# UNITED STATES PATENT AND TRADEMARK OFFICE

APPLICATION NO.	FILING DATE	FIRST NAMED INVENTOR	ATTORNEY DOCKET NO.	CONFIRMATION NO.
09/684,462	10/06/2000	Mark A. Kottman	087522785134	3279
7590 11/25/2003				
Russell L. McIlwain Jones, Day, Reavis & Pogue 77 West Wacker Chicago, IL 60601-1692				
EXAMINER HORTON, YVONNE MICHELE				
ART UNIT 3635 PAPER NUMBER

# Office Action Summary

**DETAILED ACTION**

FIG. 2

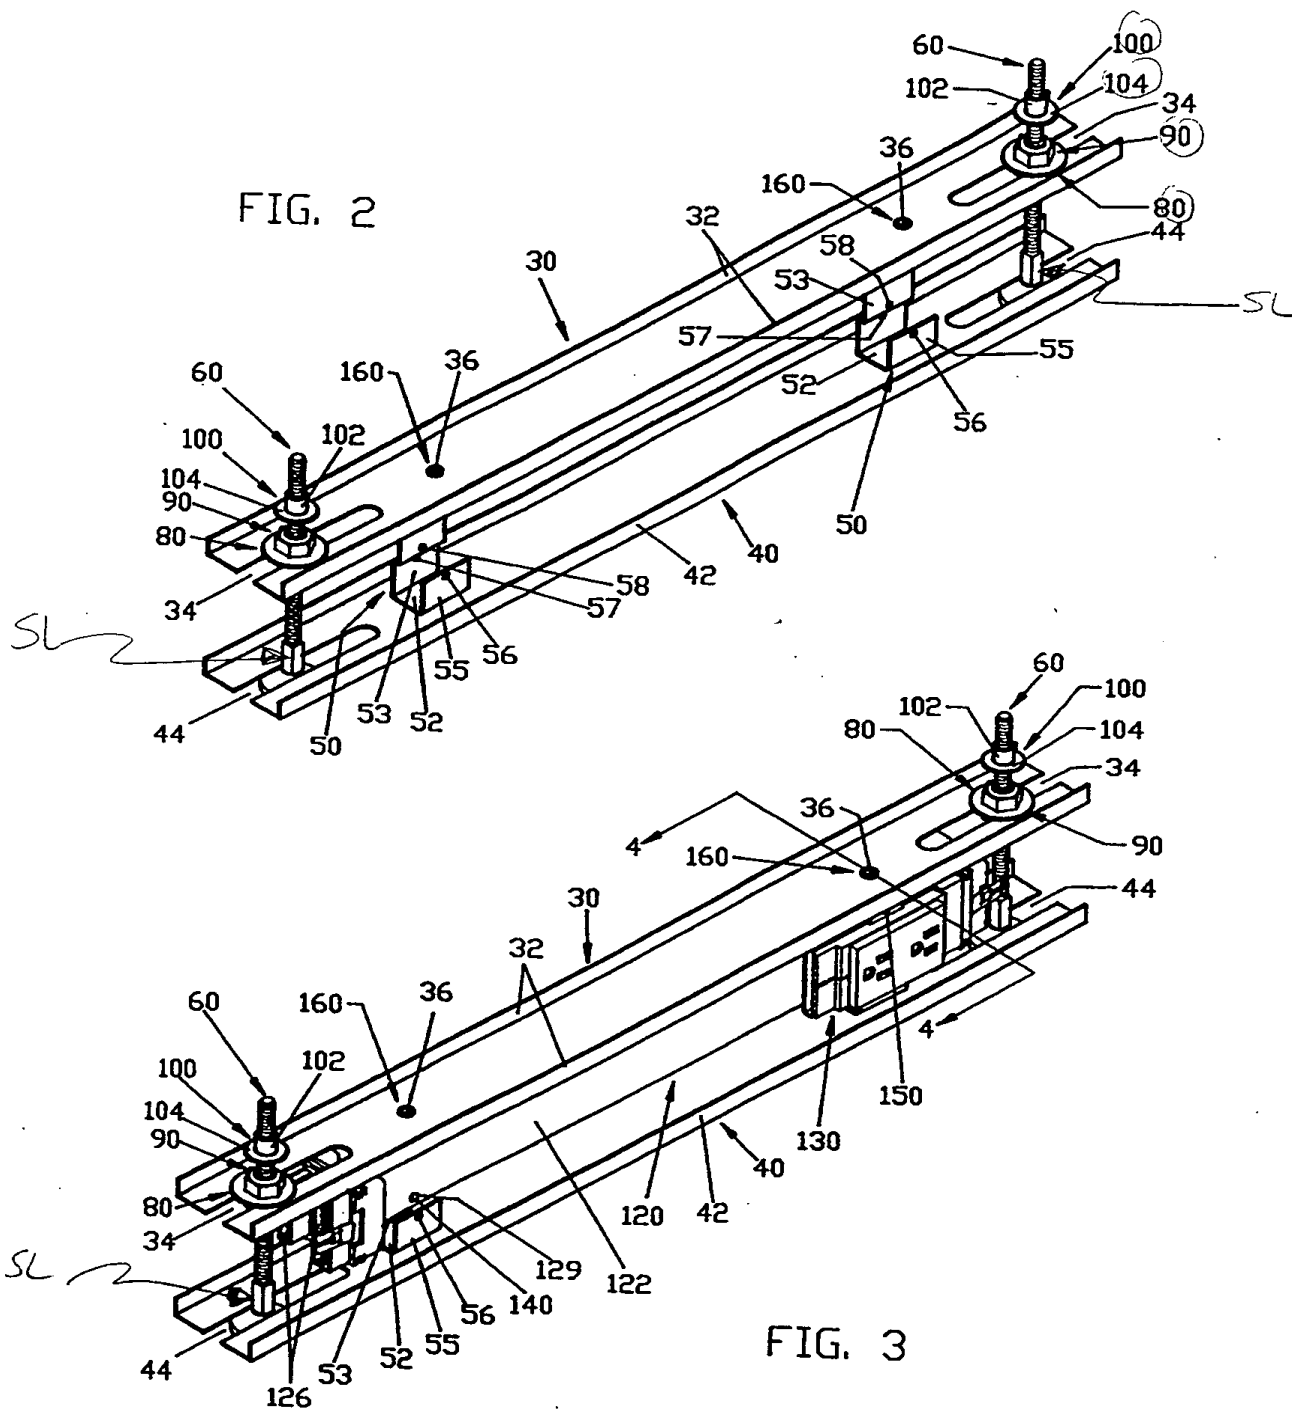
5. Claims 4-6 stand as being rejected under 35 U.S.C. 102(b) as being anticipated by US Patent #5,381,994 to WELCH. WELCH discloses the use of a modular wall panel including a

lower channel member (30), a base rail (40) disposed beneath the lower horizontal member (30), a connector (60) including a threaded sleeve (SL); wherein the connector (60) also serves as an adjustment member. The connector/adjustment member (60) having an upper threaded portion, and the base rail includes a aperture (33,44) that can inherently receive a tool. Regarding claims 5 and 6, the lower member (30) has a base panel (10) attached thereto.

6. Applicant's arguments filed 9/08/03 have been fully considered but they are not persuasive. In regards to the applicant's argument that sleeve (100), the action was in error. However the rejection has be adjusted to include the intended element number. This new rejection sets fourth that the threaded sleeve is indication as element number (SL).
